Whale Tail 2022 Annual Open Pit Geomechanical Inspection

March 17, 2023

**RE: Meadowbank Complex - Amaruq Site - 2022 Annual Open Pit
Geomechanical Inspection**

Observations - Phase 1 North Wall

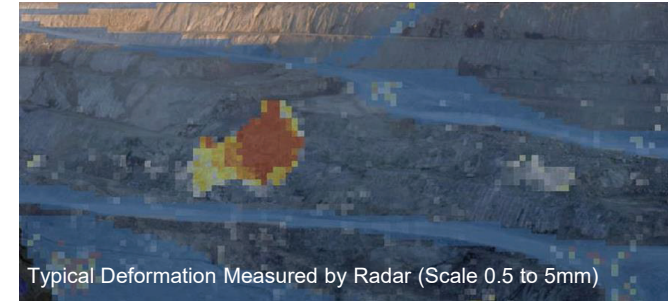
- Interim wall in Phase 1. Phase 1 has been the focus of production over the past year.
- The wall was established in the Komatiite, parallel to the foliation. As expected, a series of bench-scale failures have occurred in areas where the foliation locally dips at a shallower angle than the bench face.

- The implementation of a 55° pre-shear has improved slope performance and half barrels are visible in many areas. Bench-scale failures have and will continue to occur. AEM continues to complete extensive scaling in this sector in order to remove potential hazards and reduce the likelihood of a failure. This is endorsed.

- The bench failures almost always occur during freshet or the summer months.
- As a result, the development of the ramp along the this wall was prioritized during the 2021-2022 winter in order to minimize the rockfall risk to personnel. A berm was installed along the inside of the ramp prior to freshet.

- Two areas of instability have developed along this wall in 2022 (outlined in the image at right) and are described on the following slides.

Observations - Phase 1 North Wall (3)

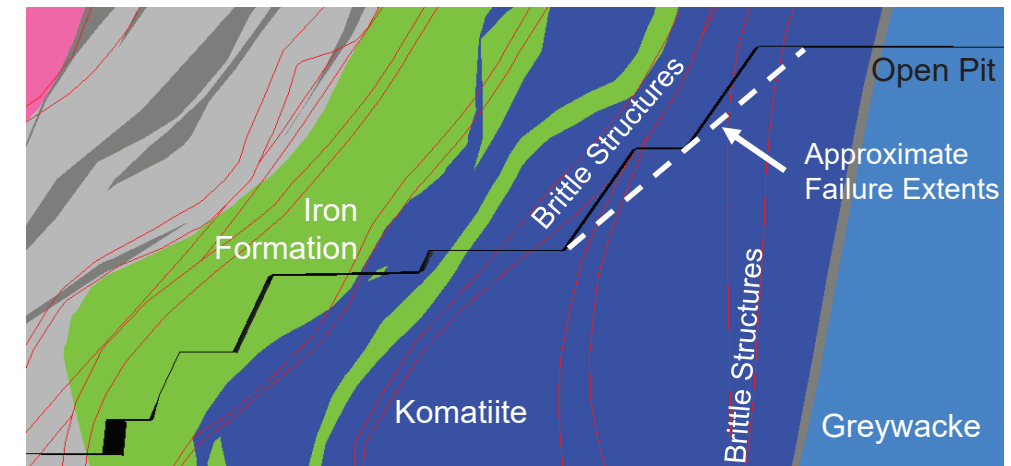
- A review of the lithology model suggests that the failure is unlikely to propagate significantly further back behind the crest due to the presence of the Greywacke.

- The potential for the failure to continue to propagate with depth was discussed as the structure defining the eastern boundary of the failure daylights below the ramp. The failure is larger than others along the Phase 1 North Wall and should be reviewed in greater detail to better understand the failure mechanism, likely contributing factors, and the potential for the failure to continue below the ramp. It may be possible to use the radar data to better understand the possible structural controls on the failure. A Maptek scan is recommended to document the failure geometry in detail.

- The Phase 1 pit will be used as a sump for managing water into 2024. Personnel will be travelling on the ramp below this failure during that time.
- Options for reducing the risk to personnel if the failure continues to progress were discussed. These include:

- Buttressing the failure. This would limit the ramp to single lane traffic but that is expected to be manageable.
 - Allowing the water level to rise a point on the ramp above the failure. This would allow the pumps to be located above the failure, removing the requirement for personnel to travel below the failure. However, the infiltration of water into the toe of the failure mass would like adversely influence the performance of the failure. The potential risks associated with storing this much water above the underground workings would also need to be reviewed.

- The failure should continue to be monitored with the radar and the berm maintained.
- Once mining of Phase 1 is complete, the risks associated with on-going access below the failure should be reviewed and mitigation measures implemented as appropriate.

Observations - Phase 1 North Wall (4)

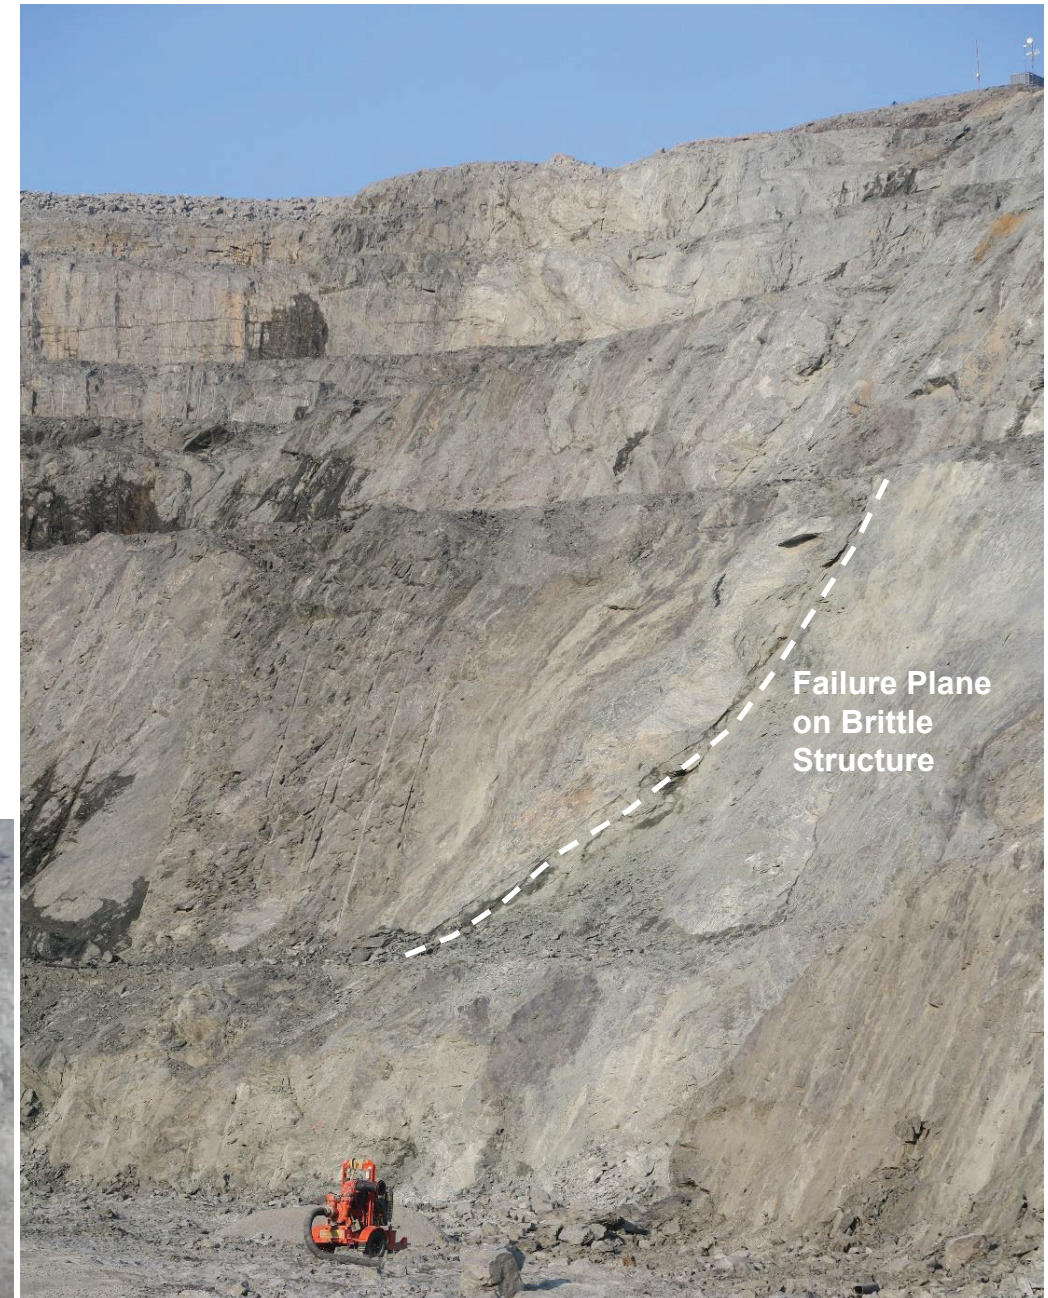
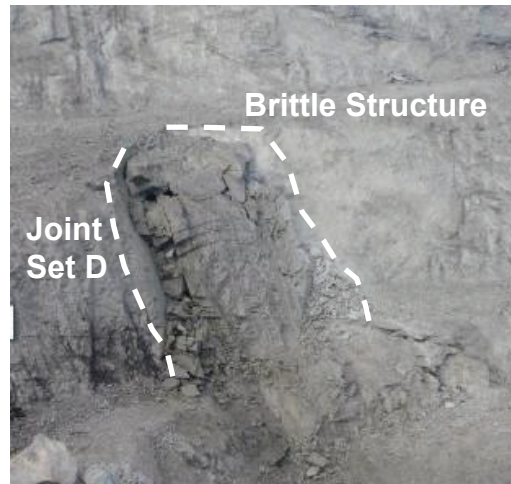
- During the site visit, a possible instability at the western end of the wall was identified based on trends in the radar monitoring data.
- A wedge is present on the wall, formed by a brittle structure and a cross-cutting structure (likely Joint Set D). The rock mass below the brittle structure is Komatiite but it is not clear if the wedge itself is Komatiite.
- The area was barricaded and access prevented. Due to the timing of the event, the pump shown in the photo was left within the barricaded area.
- After the site visit, a portion of the wedge failed in place on August 16 (see inset below). A small step-in with a berm has been left below the failure to allow mining to continue in the area.
The area should continue to be monitored.
- The failure will be mined out when Phase 1 is pushed back to the final pit configuration.

Observations - Northeast Wall

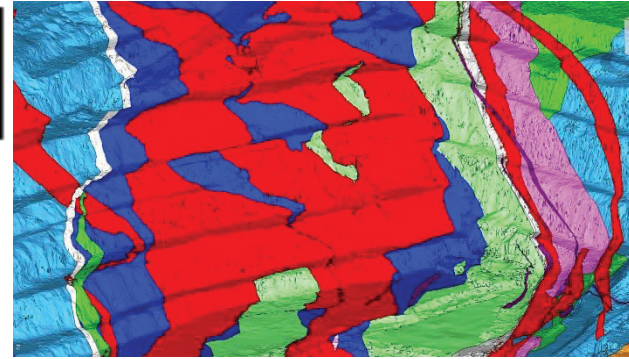
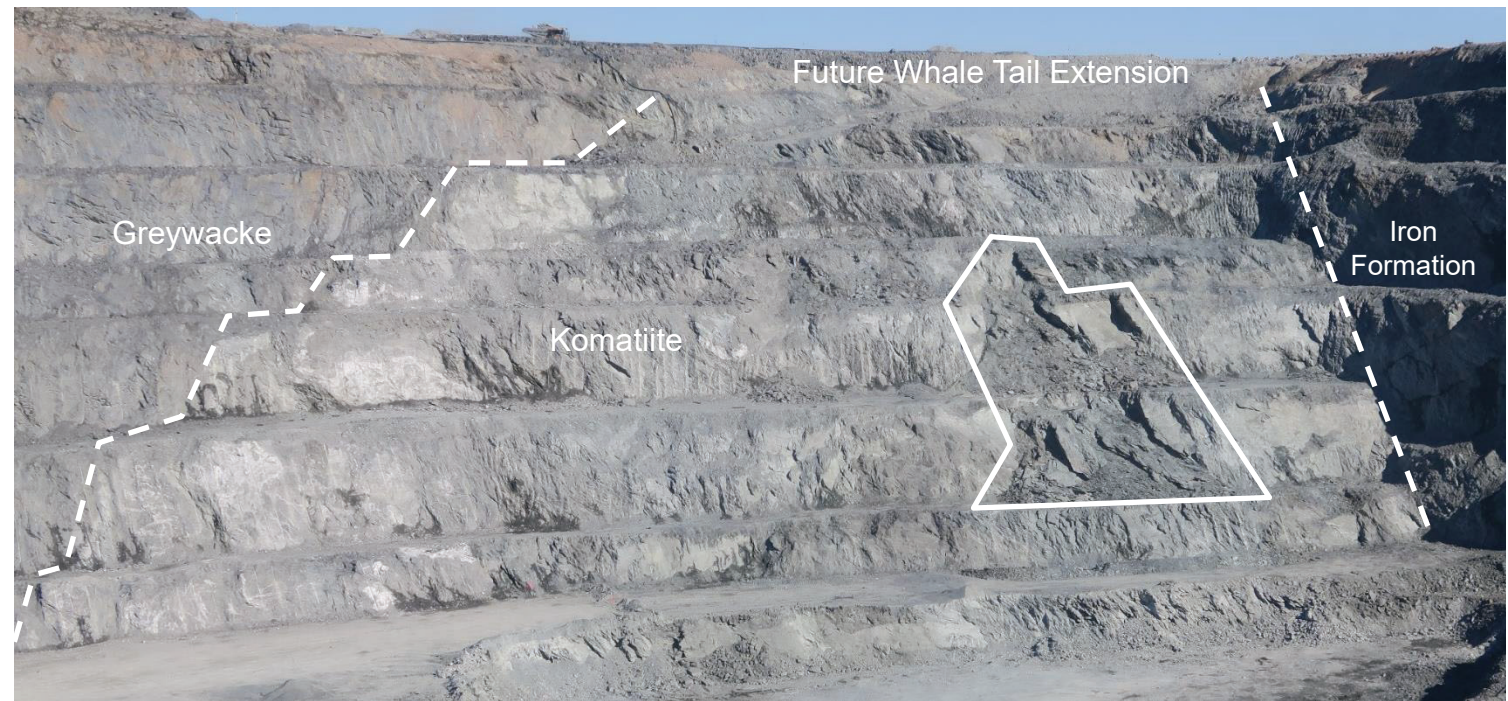
- Final wall in Design Sector D4K.
- This sector is within the Komatiite and has been characterized by a series of bench scale failures. The failures are currently understood to be a hybrid of failure on the foliation and failure of the weak rock mass, influenced by water (i.e., a combination of seepage within the talik and surface runoff) and the Brittle Structures.

- A revised slope design was developed in December 2021 and a pushback of the upper two benches completed to re-establish the slope. The pushback will eventually form part of the planned Whale Tail Extension to the northeast.

- The wall continues to be a focus for the Rock Mechanics team. Assessments of the overall slope stability using a numerical model and of the planned lower wall using kinematics are in progress.

- The performance of the benches has improved with the revised slope design. Several bench-scale failures have occurred and will continue to occur.
- A series of bench-scale failures have occurred at the eastern end of the sector (outlined at right). The failures have almost, but not yet, linked up. This area is discussed on the following slide.

Observations - Northeast Wall (2)

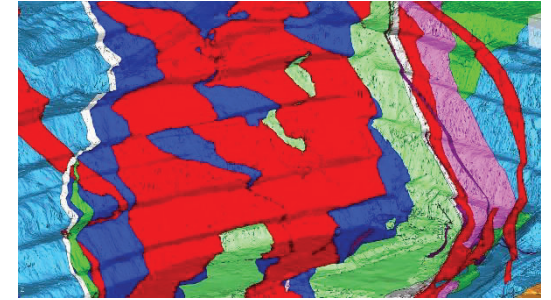
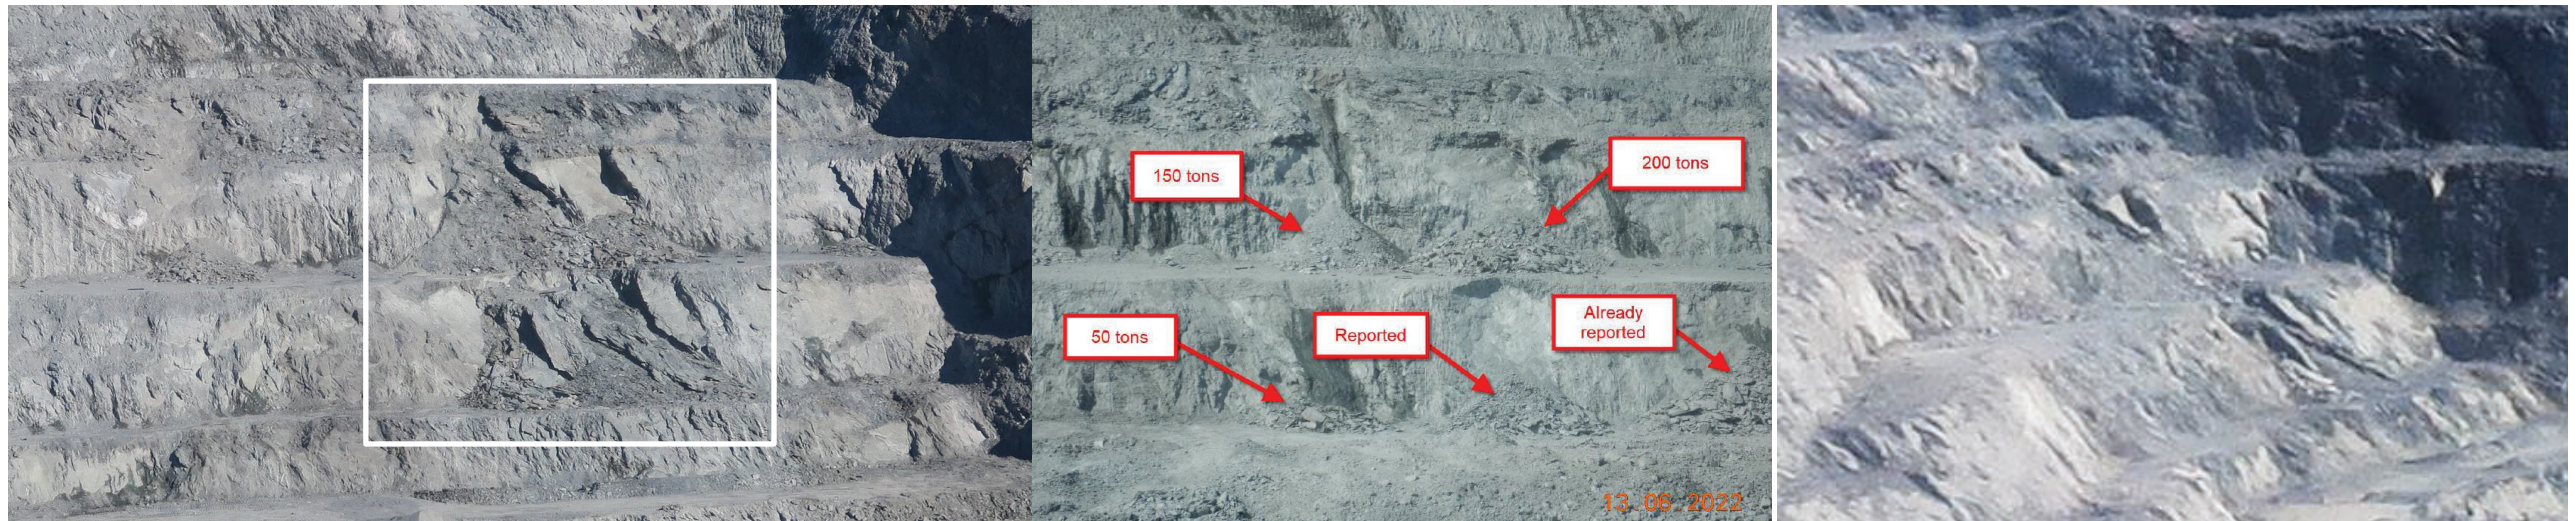
- Seven rockfalls and bench scale failures have been reported in this sector in 2022, ranging in tonnage between approx. 150 and 1500 tonnes. All but one are associated with a series of progressive failures associated with the area outlined in the left photo.

- The failures occurred during freshet, between May 28 and July 17, with most occurring in June. Failures were expected and a rockfall berm was constructed below this area prior to freshet.

- The middle photo shows the outlined area at the time of many of the initial failures in June. These failures were relatively small and several appear to be associated with surface water or erosion of the face (see next slide). The rock mass quality was noted to reduce as the rock mass thawed and these failures progressed over time. The failures on the two benches have almost linked up.

- The western limit of the failures appears to be defined by the foliation. The eastern limit of the failures appears to have a structural control (see right photo). This may be one of the brittle structures (see image at upper right, with brittle structures in red).

Observations - Northeast Wall (3)

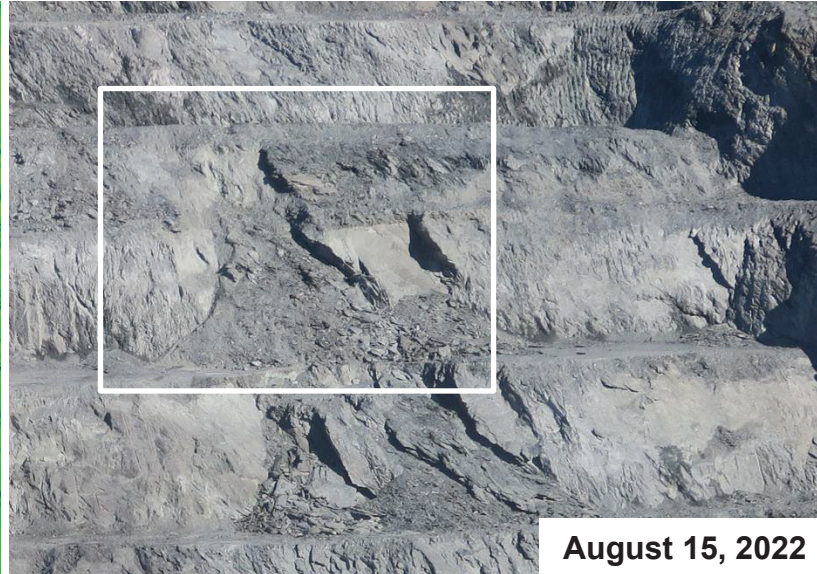
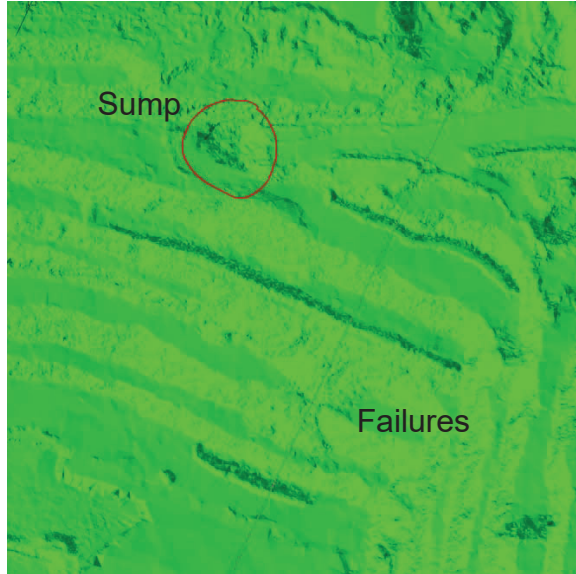
- The site team believes that the infiltration of surface water and the erosion of brittle structures in the bench face likely contributed to the initial failure in May.

- The pushback is located within the drainage for what was the northeastern lobe of Whale Tail lake and water reports to the area. An unlined sump has been established at the base of the pushback at the top of the slope (left photo). The sump is on the Komatiite-Greywacke contact, which is likely promoting infiltration.

- Photos prior to the failures show surface water running across the bench face and eroding the weak rock mass (right photo). The water appears to be concentrated along the potential structure bounding the western edge of the failures.

- It seems reasonable that water is contributing to the failures. It is recommended that surface water be diverted away from the area to the extent possible and that the sump be lined.

Observations - East Wall

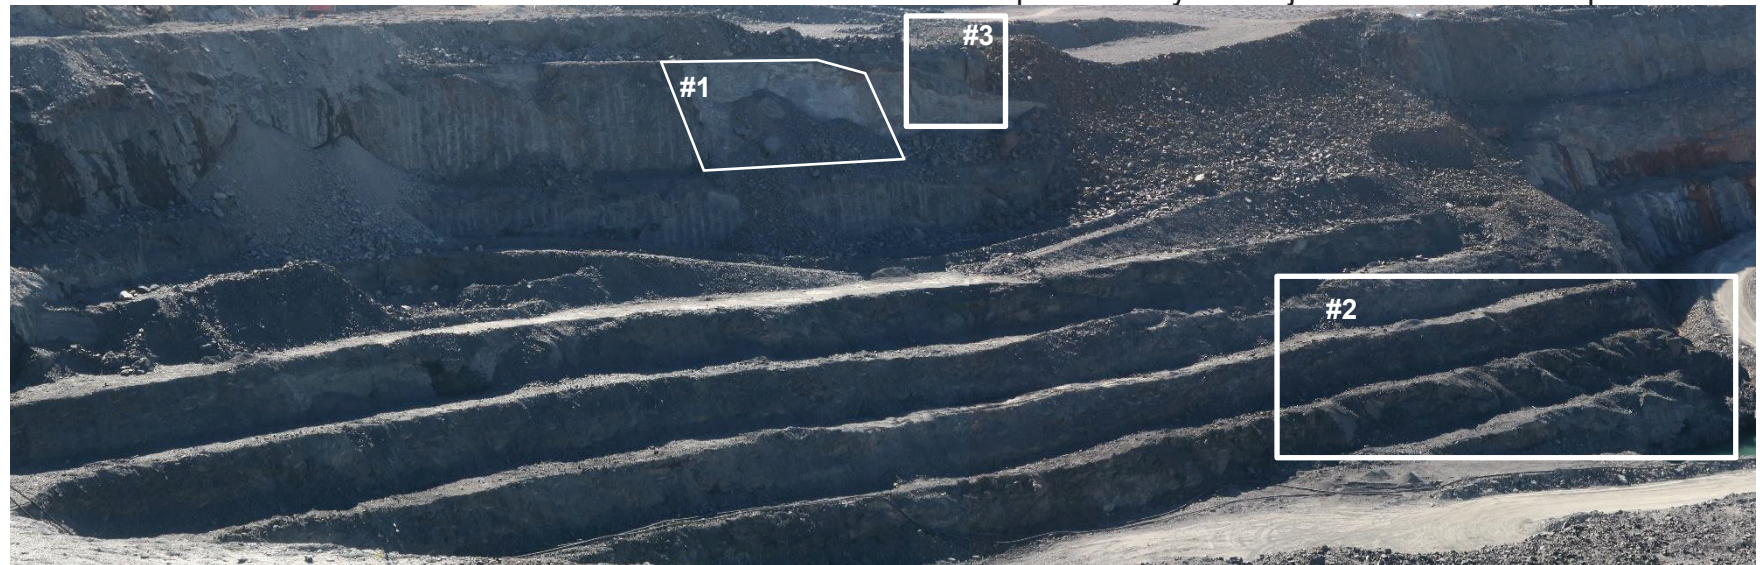
- Final wall in Design Sector E4.
 - Limited mining has occurred along this wall since the 2021 review. Specific areas of note are listed below and outlined on the photo.

1. Material from a former in-pit dump remains on the face of the upper bench. A rockfall berm was constructed to retain ravelling material. No significant changes have been observed.

2. The Greywacke near the Diorite has experienced crest loss and previous rockfall events. A temporary step-out has been left below the area to reduce the exposure to personnel. The intention is to scale the area, clean the catch benches and recover the step-out as part of the Phase 3 pushback. This is endorsed. Several potentially unstable blocks were previously identified and should continue be monitored as part of the visual inspections. The drone should be used to supplement these inspections.

3. A joint set cross-cutting the foliation and dipping to the north is prominent in the Iron Formation near the Komatiite contact. It has locally resulted in increased crest loss.

Observations - Phase 2 Southeast Wall (3)

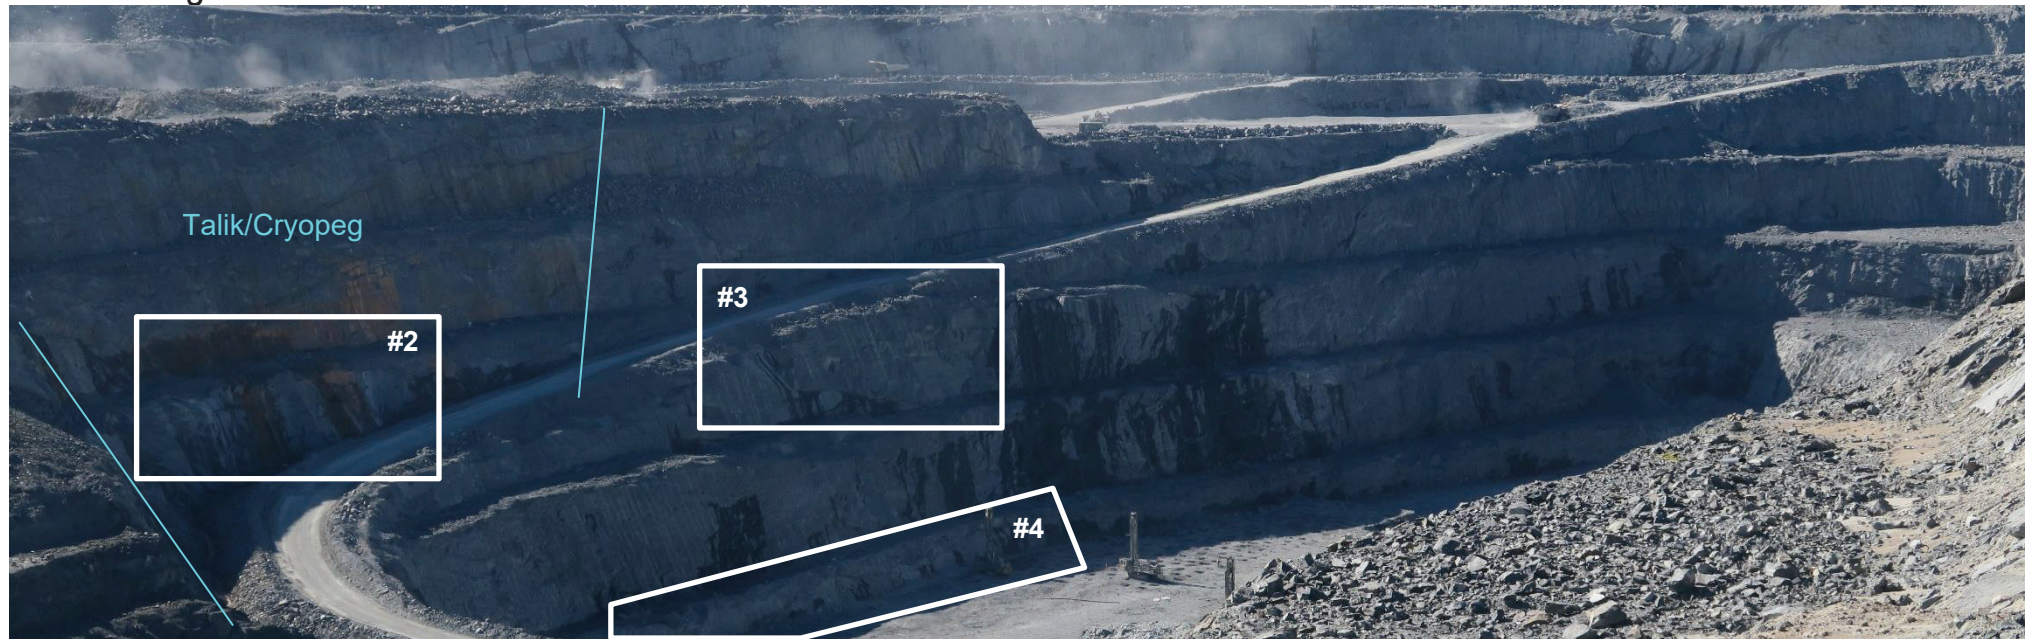
- A Brittle Structure was observed at the western end of the wall, adjacent the Phase 2 ramp.
- This structure (#3) is modelled along the northern contact of the South Limb Komatiite. The observed position, orientation, and thickness of the structure agree well with the 3D structural model.
- No particular stability concerns were noted.
- In general, the 3D structural model has not been validated against the exposures in the open pit. Recommend doing so to build confidence in the model as it is being used to inform key design decisions.

Observations - Phase 2 South Wall (2)

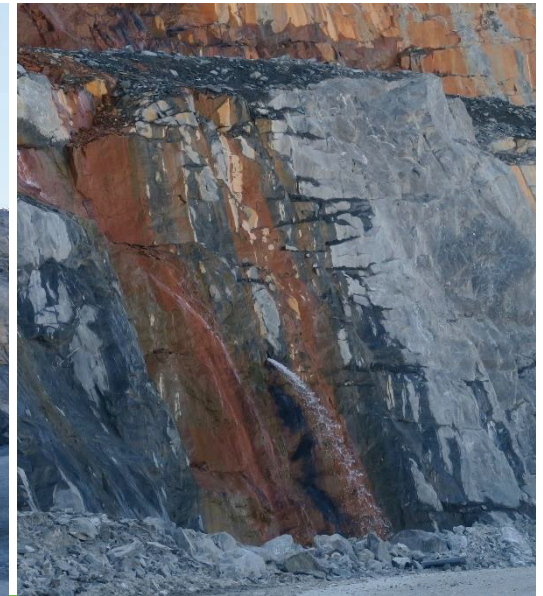
1. Spillover from the Phase 3 pushback has accumulated on the catch benches above the Phase 1 ramp and has previously blocked the ramp. The mine has limited the ramp to light vehicles and has partially constructed a rockfall berm along the inside of the ramp. The berm needs to be extended along the full length of the ramp and built up to ensure a consistent 2 m height (left photo). Some rockfall has accumulated behind the berm and it will need to be regularly inspected and maintained.

2. Prominent seeps are present in the lower South Wall, concentrated along sub-horizontal structures (centre photo). The seepage resulted in an ice wall but no significant ice falls occurred and the mine was able to manage this successfully. A water-management pushback has been planned to help mitigate this risk, which is endorsed. A test horizontal drain hole was completed (right photo) and has both consistently made water (including over the winter) and influenced the seeps on the wall. This suggests that horizontal drains may be viable in intercepting and managing seepage.
